QUALITY ASSURANCE -- NON-CONFORMANCE REPORT

Report No: NCR-000582

NCR #: ZPMC-0555

Reference Description: Perform of heat straightening in Segment 10CE without Engineer's approval

Description of Non-Conformance:

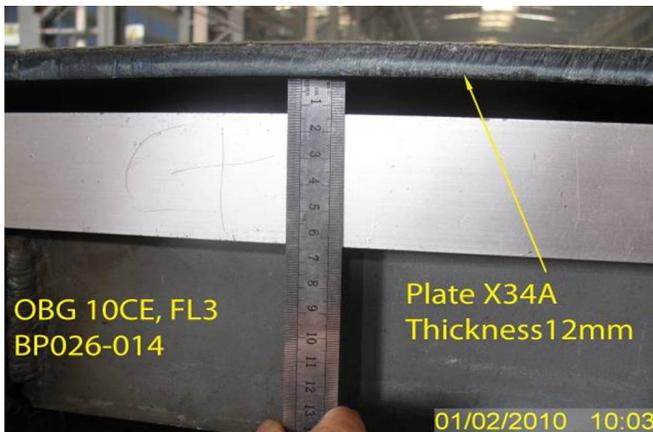
During the Quality Assurance (QA) in-process inspection of the FL3 floor beam bottom plate components, this QA inspector discovered the following issue;

- ZPMC personnel performed heat straightening on OBG segment 10CE, FL3 Bottom Plate without the prior approval of the engineer.

-The Bottom Plate assembly is identified as BP026-014 and the plate is identified as X34A, which measured to be a total of 12.5mm out of straightness in 1000mm.

-ZPMC QC or CWI were not present during the time of the heat straightening process.

Propose a resolution for the identified non-conformance with revised procedures to prevent future occurrences. After the HS plan is reviewed and approved notify the engineer prior to starting HS activities. A response for the resolution of this issue is expected within 7 days.

Description of Non-Conformance:

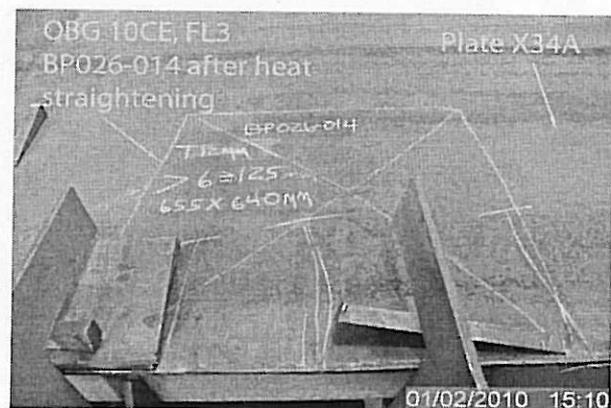
During the Quality Assurance (QA) in-process inspection of the FL3 floor beam bottom plate components, this QA inspector discovered the following issue;

- ZPMC personnel performed heat straightening on OBG segment 10CE, FL3 Bottom Plate without the prior approval of the engineer.

-The Bottom Plate assembly is identified as BP026-014 and the plate is identified as X34A, which measured to be a total of 12.5mm out of straightness in 1000mm.

-ZPMC QC or CWI were not present during the time of the heat straightening process.

This proposed resolution is acceptable. The Department concurs that Non-Conformance ZPMC-0555 is closed.

Description of Non-Conformance:

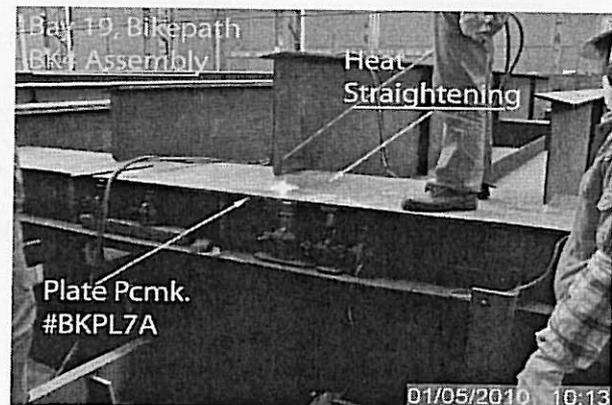
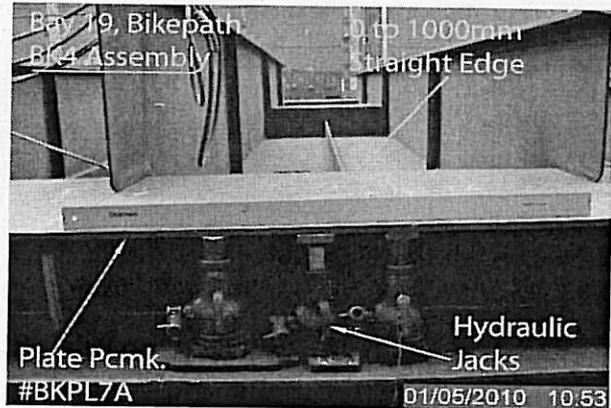
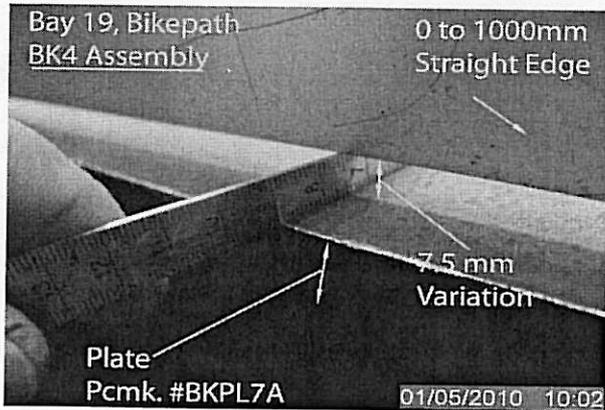
During the Caltrans Quality Assurance in-process observations of the fabrication of the bike path components in assembly bay 19 this Quality Assurance Inspector (QA) discovered the following issue:

- ZPMC heat straightening an area of material distorted by welding without the Engineers approval.
- The bike path segment is identified as BK4.
- The part is identified as BKPL7A.
- The deviation from flat as measured by this QA was 7.5mm per 1000mm.
- Material thickness is 16mm.
- ZPMC QC was not present during the time of the heat straightening process.

Propose a resolution for the identified non-conformance with revised procedures to prevent future occurrences. Do not perform HS without prior notification of the engineer. A response for the resolution of this issue is expected within 7 days.
